Development Review Committee Comments | 6/21/2022
Case PLAT22-0023
Hometown Dolce Addition (6021 Parker Blvd)

WRITTEN STATEMENT OF CONDITIONS

Replat - PLAT22-0023 Hometown Dolce Replat
Proposed Commercial Parking Plan – 47 Commercial Space Required

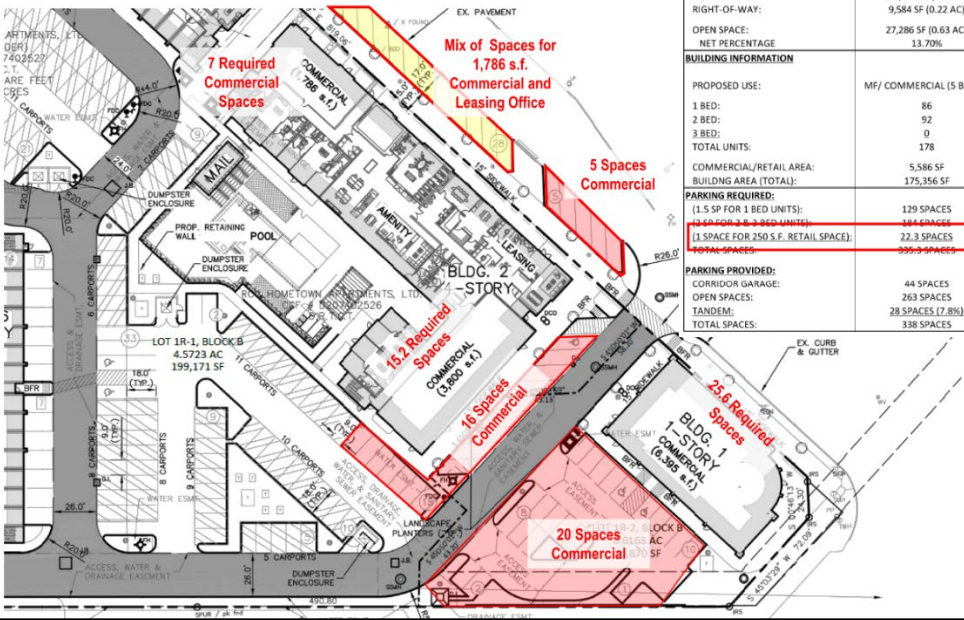
1. Add the City case number near the bottom right corner of the drawings (Case PLAT22-0023).
2. In order to accommodate 26 parking spaces for Lot 1R2, the plat is designed to split an existing row of parking between Lot 1R1 and Lot 1R2. While this satisfies the required parking for Lot 1R2, it removes commercial parking that would support existing commercial space on Lot 1R1. It also creates issues in determining property ownership and responsibilities for maintenance, upkeep, and liability of the parking area. Additionally, residents of Sovereign have taken over use of the parking on future Lot 1R2 and the angled commercial parking on Lot 1R1.

The Development Review Committee strongly recommends that Sovereign develop and record a reciprocal parking agreement between Lot 1R1 and Lot 1R2 that accomplishes the following (see attached exhibit).

- a. Dedication of 28 parking space on Lot 1R1 to support commercial space on both lots. Of the 28 spaces, 21 spaces would be located on Lot 1R1 to wrap the 3,800-square-foot commercial building, including five (5) angled spaces on Parker Boulevard in front of the leasing office.

- b. Dedication of seven (7) spaces on Parker Boulevard to support the 1,786-square-foot commercial frontage in the mid-block area.
 - c. Revise the replat to exclude the angled parking spaces fronting the 3,800-square-foot commercial building from Lot 1R2 and return the spaces to Lot 1R1. The reciprocal parking agreement will satisfy the parking requirements for both lots.

- d. Implement a “Business Customer Parking Only” signage and striping plan so that Sovereign residents do not park on dedicated commercial parking on either lot.
